SERVICE *No.* 1026 BULLETIN

DATE: November 5, 1998 (S/M)

**Distribution of Parker Hannifin Airborne
Service Letter 48, "Inspection/Replacement
of dry air pump flexible couplings".**

Service Letter Number: 48

FIGURE 1

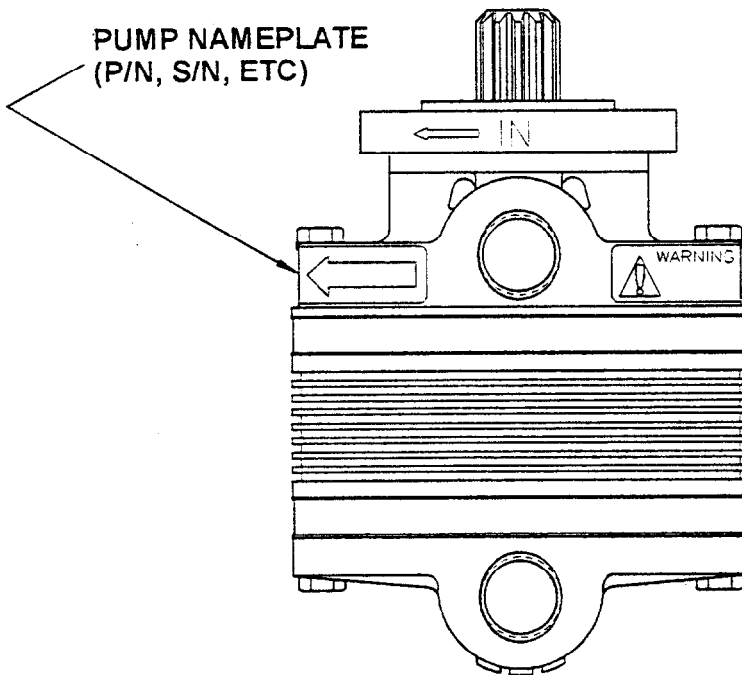
Applicability: Airborne dry air pumps, conversion kits and flexible coupling kits with the following part numbers/serial numbers which have not been inspected per this service letter as identified in step number seven of the procedure listed below. These components were shipped from Airborne between 1/1/98 and 10/13/98. Refer to Figure 1 for location of part number/serial number nameplate.

- 7) Identify this dry air pump as having been inspected per this service letter by permanently marking (ink stamp, magic marker, etc.) the number of this service letter ("48") on the backflange of the pump near the discharge port.
- 8) Reinstall dry air pump onto engine accessory pad per instructions provided by the airframe manufacturer in the appropriate maintenance publication.
- 9) Check for proper operation of aircraft pneumatic system per instructions provided by the airframe manufacturer in the appropriate maintenance publication.

FIGURE 2

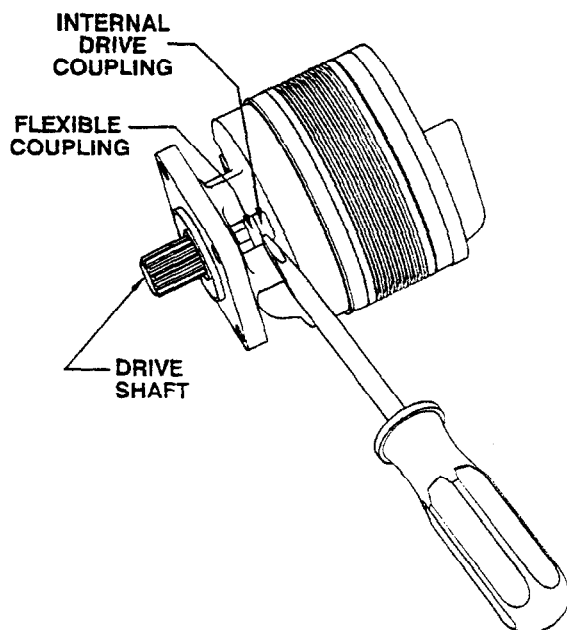
- 1) Remove dry air pump from engine accessory pad per instructions provided by the airframe manufacturer in the appropriate maintenance publication.
- 2) Insert a screwdriver or similar tool between the flexible coupling assembly (2-piece) and the pump's internal drive coupling. Remove the flexible coupling assembly from pump, taking care not to damage any of the eight drive pins. Refer to Figure 2.

- 6) Reinstall the replacement/inspected flexible coupling assembly onto air pump by pushing it over the drive pins of the pump's internal drive coupling as far as it will go. Do not tap coupling assembly with any device as the pump's bearing may be damaged.
